# Ideas considered and set-aside

# Set aside: Truss (Two, three and clear span)

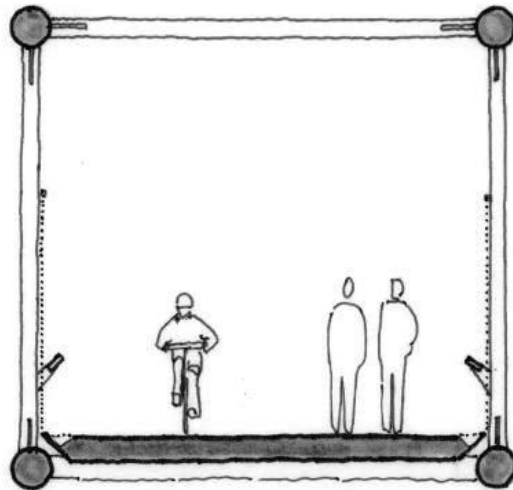
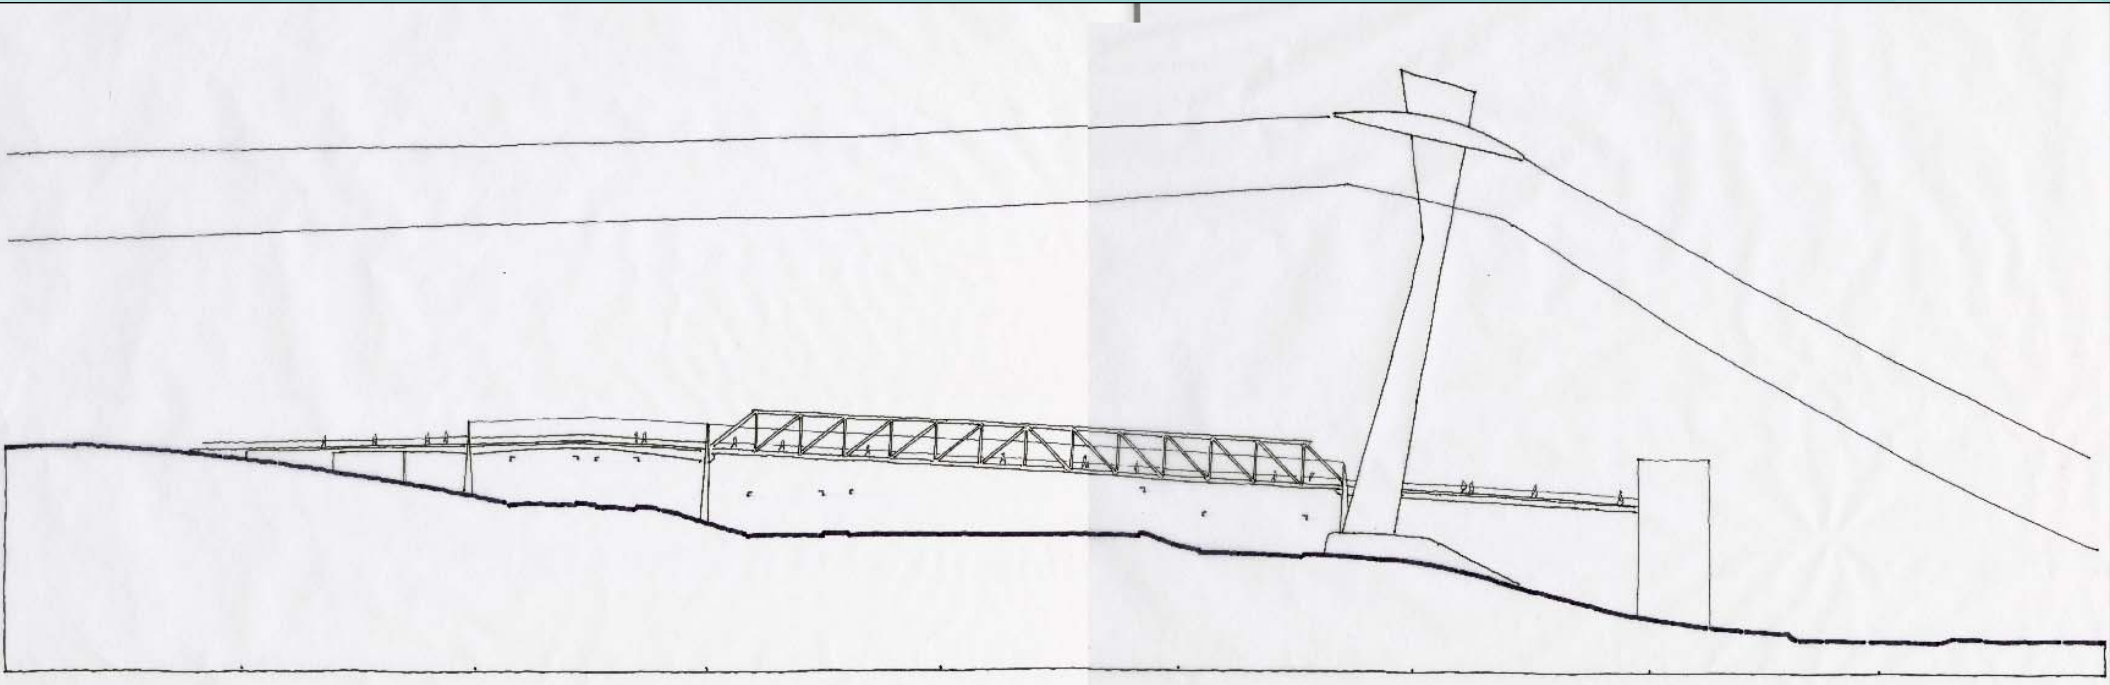
- Given the length of the spans, the truss may not be able to be fabricated off-site. This would minimize the benefits generally expected – off-site fabrication which reduces construction traffic disruption and cost savings.

- The user experience would be less open and comfortable than with other bridge options.
- The “railroad bridge look” seems out of context with the aerial tram.

# Connection to Macadam Avenue

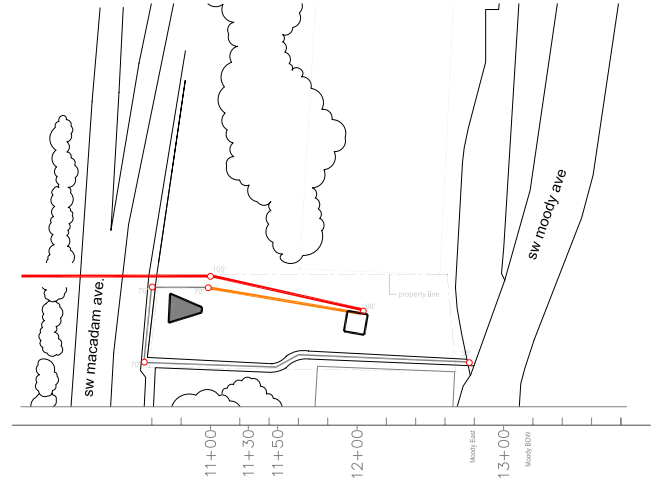
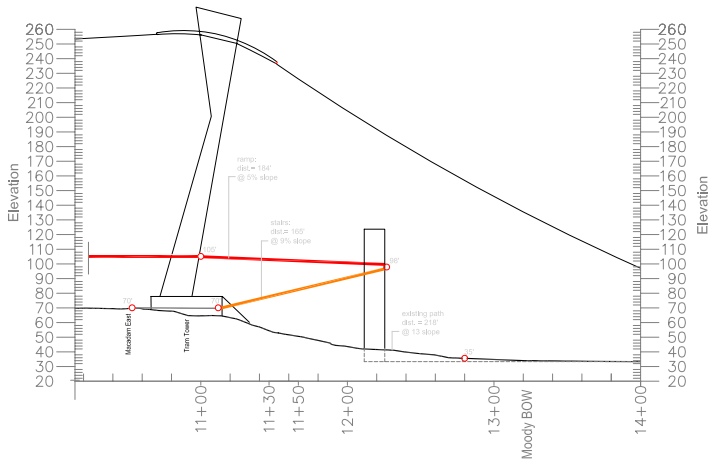
It does not make sense given the cost because:

- Macadam Avenue doesn't connect users to important destinations.
- Ramp connection would still be steep (12-18%).
- Stair connection to Macadam Avenue would not provide a benefit for many users relative to the elevator to Moody Avenue.
